**KNOXVILLE HISTORIC ZONING COMMISSION
STAFF REPORT - CERTIFICATE OF APPROPRIATENESS APPLICATION**

PROPERTY ADDRESS: 119 W Glenwood Ave 37917

FILE NO.: 3-C-14-HZ

DISTRICT: Old North Knoxville H-1

Proposed Floorplan

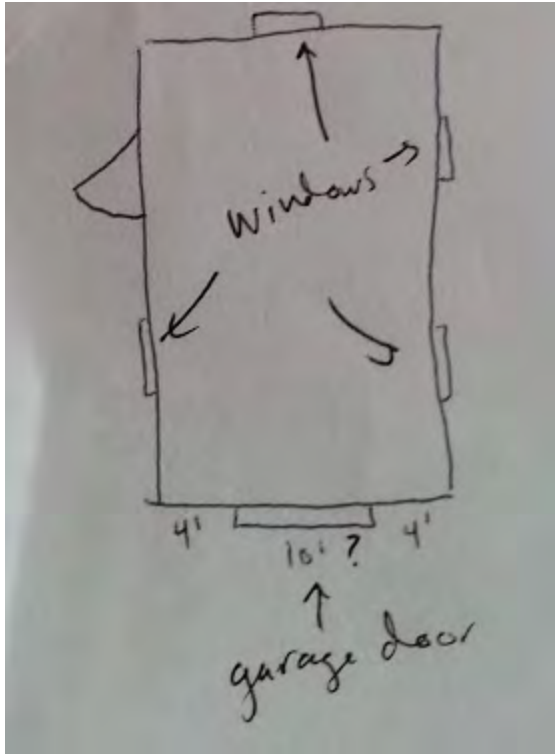
Current Floorplan

ReliaBilt 8-ft x 7-ft 950 Series Insulated White Garage Door with Windows

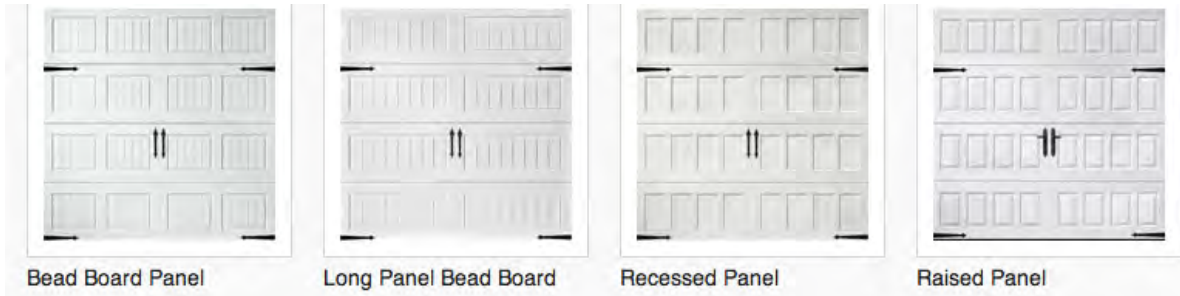
Garage Door Options

This door seems to be the closest fit to the current door based on the selection in area stores:

But we're okay with any variation. Since it will face the street (W Glenwood) instead of the alley on the north side, this style is also okay with us:

- 1) The proposal meets the design guidelines in that the design of all replacements are proposed to be in-kind.
- 2) The materials of the proposed garage doors may be either steel or fiber cement board. There is precedent for approval for these materials on garage doors in the Old North Knox District.
- 3) There are examples of garage doors on both the front and back of garages in the district. The relocation of the garage doors from the rear of the garage to the front does not create a significant change in character for the property and will help the garage to stay viable into the future.
- 4) The garage doors will have a Craftsman appearance without windows as are the existing doors.

Staff recommends approval with the final Craftsman garage door design to be chosen from those presented with this submittal.

Carriage House Garage Door Window Options

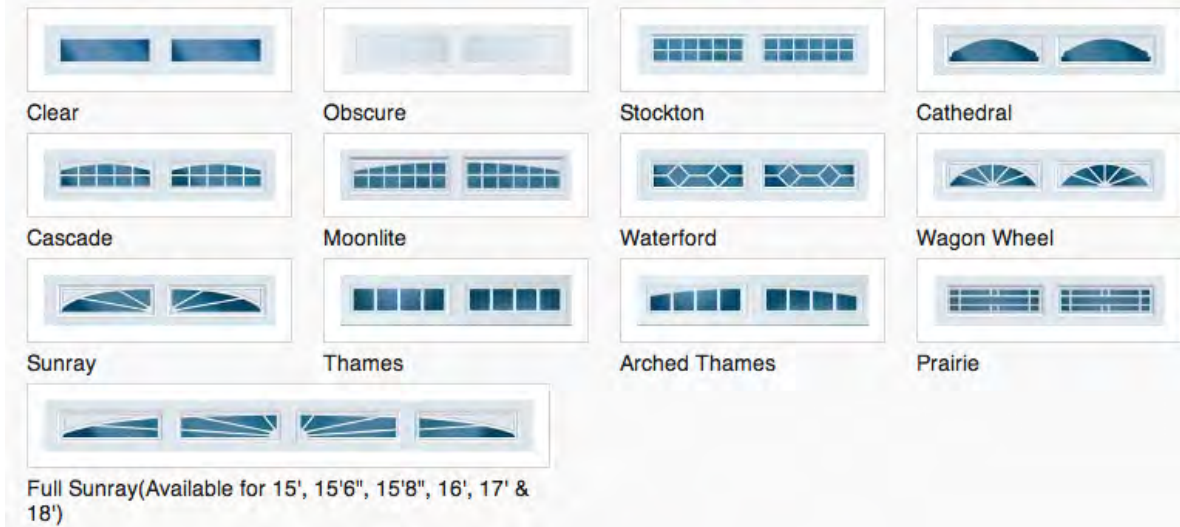
We could also get quotes from Sears mixing and matching door patterns, windows and hardware:
